# **Intel<sup>®</sup> Ethernet Controller I210**

**Specification Update**

Revision 2.5  
332763-009

Figure 1-1 Explanation of Top Markings for A3 Stepping

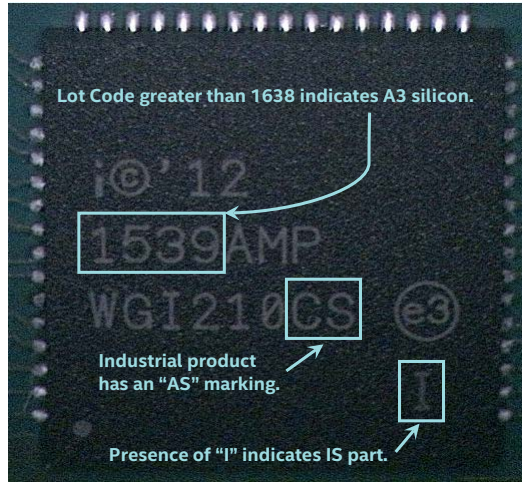
The A3 stepping only applies to the Fiber (IS/CS/CL) products. The A3 stepping can be identified by the Fab Lot Trace Code marking on the package or by the iNVM contents.

- Fab Lot Trace Codes starting with 1638 or greater are A3 devices.
- Bit 1 of INVM\_DATA[61] (0x12214) is 1b on A3 devices.

### 4. Flash Update Integrity Firmware Enhancements

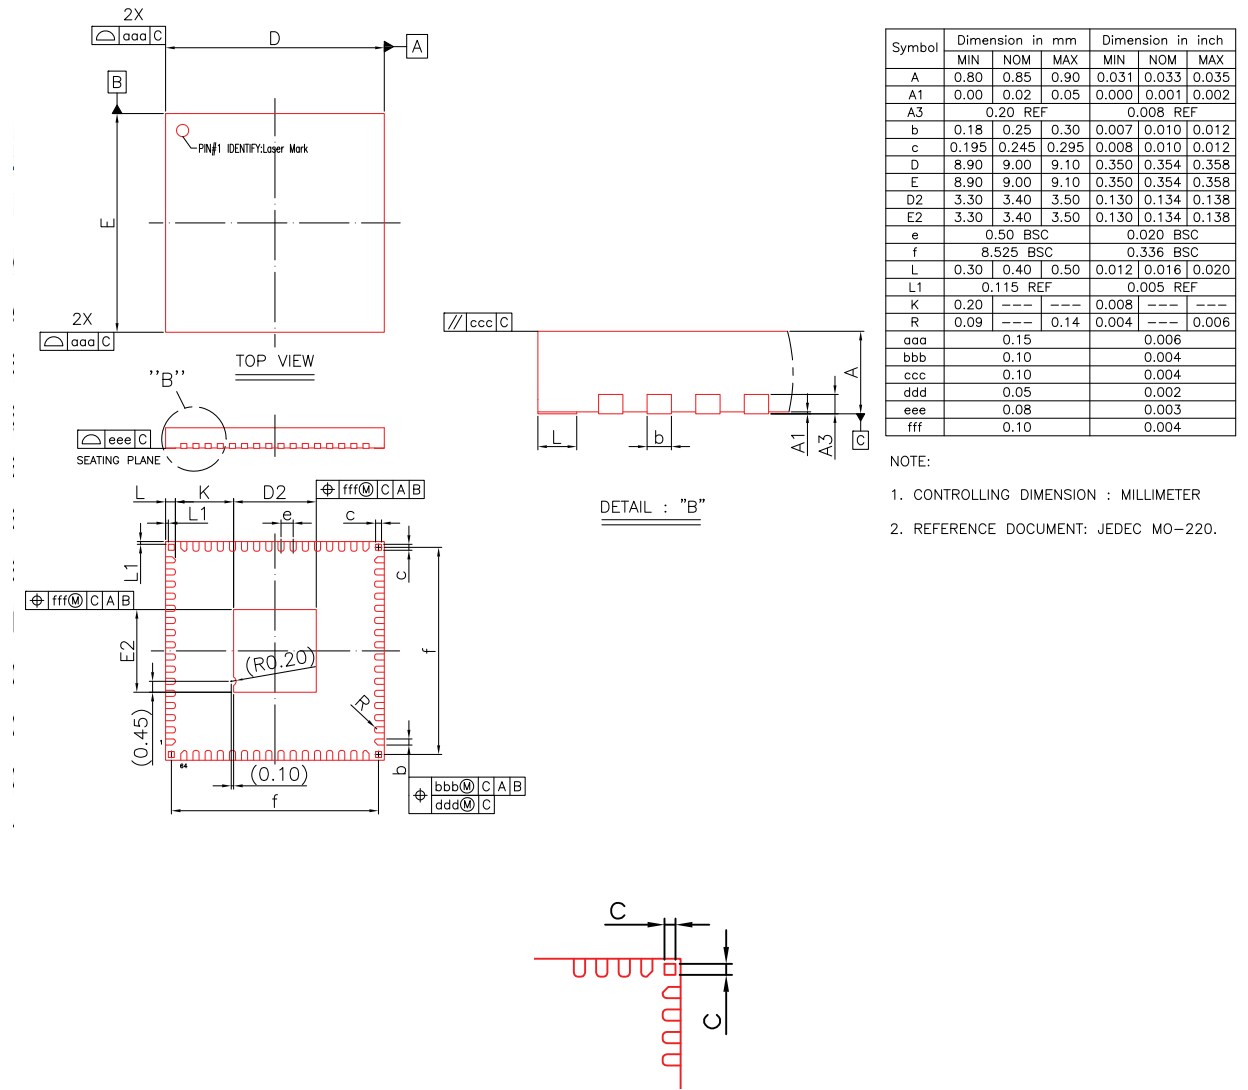
The I210 Flash Update integrity feature (Section 3.3.10 of the *Intel® Ethernet Controller I210 Datasheet*) ensures only Intel digitally signed updates can be applied to I210 products post manufacturing. This is achieved by a combination of hardware and firmware capabilities. NVM image release 3.20 includes firmware enhancements to improve the resilience of this feature.
